To: INCITS Technical Committee T10
From: Kevin Butt
Date: Monday, June 08, 2009 12:07 pm
Document: T10/08-391r2 — SSC-3: Resolution to LB IBM-L1

This proposal intends to resolve LB IBM-L21:

Encryption Parameters in a SCSI device

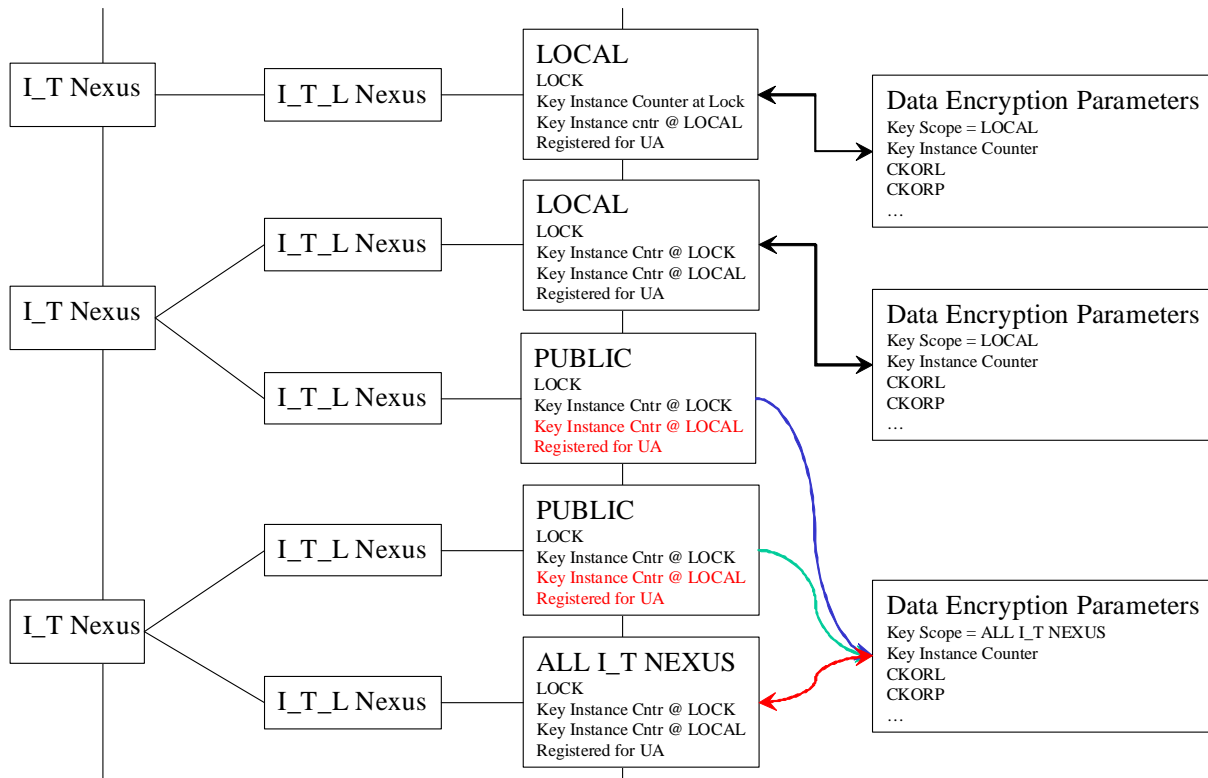
Proposal 08-266r0 (<http://www.t10.org/ftp/t10/document.08/08-266r0.ppt>) was reviewed in the past and the working group confirmed the LOCK bit is supposed to work as shown in that document. 08-266r0 was just a presentation to gain consensus and not a proposal. It is my intent to make a proposal that clarifies the intended usage of the LOCK bit as the usage is shown in 08-266r0. Unfortunately, 08-266r0 does not discuss the LOCK bit in relation to PUBLIC and encryption modes set to DISABLE.

The following figure may help discuss the LOCK bit and what is required for it to function properly. Note that the red text in the figure are parameters that are not present in the specific case.
